Assembly Alert: 181

Subject: Improved installation method for 13 Gallon Fuel Tanks.

Models Affected: All S-7S and S-20 under construction.

FIGURE 2 - Installation Detail

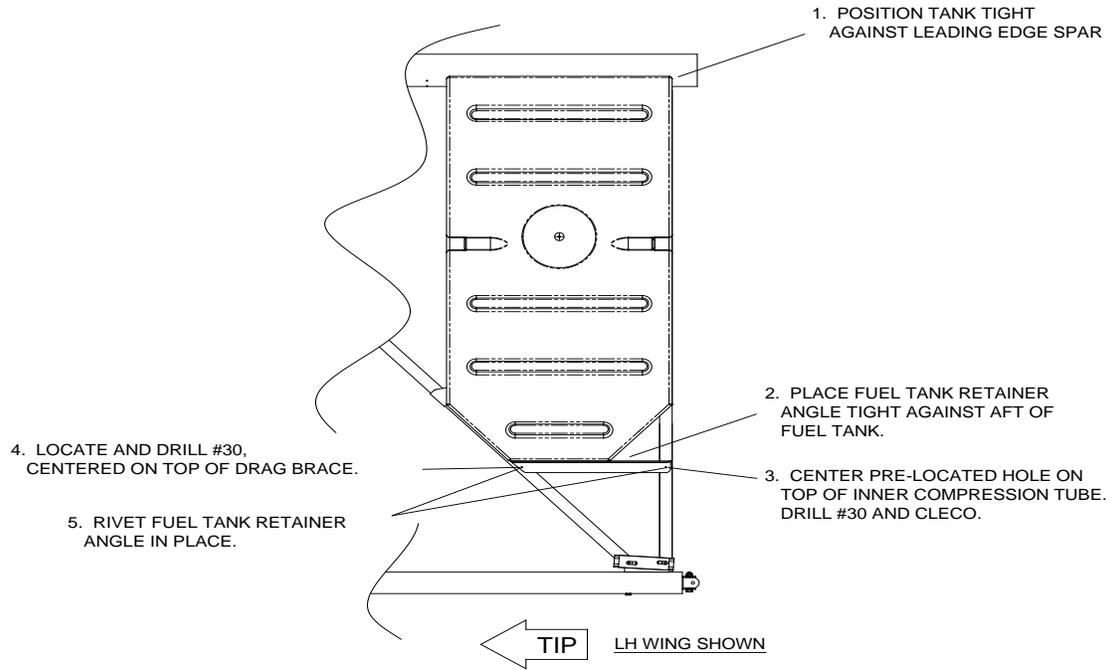
During testing of a 13-gallon tank install at the factory, a leak was discovered at one of the Insert Nuts molded into the tank. Over-torquing at these points of attach, along with possibly thinner tank walls, was cited as the cause. A simpler mounting design, not using the Insert Nuts as attach points, was created to avoid the potential leakage source. This mounting design will replace the Wing Tank - Mount Brackets (KPFS0007) with a Fuel Tank Retainer Angle (KPFS0105-L and KPFS0105-R) at the aft end of the fuel tank.

If your wing assembly is at the point of installing wing root skins, you may want to opt for this new install method. Please contact RANS Parts Dept. for the parts and instructions.

Refer to **FIGURE 1** and **FIGURE 2** below for installation details.
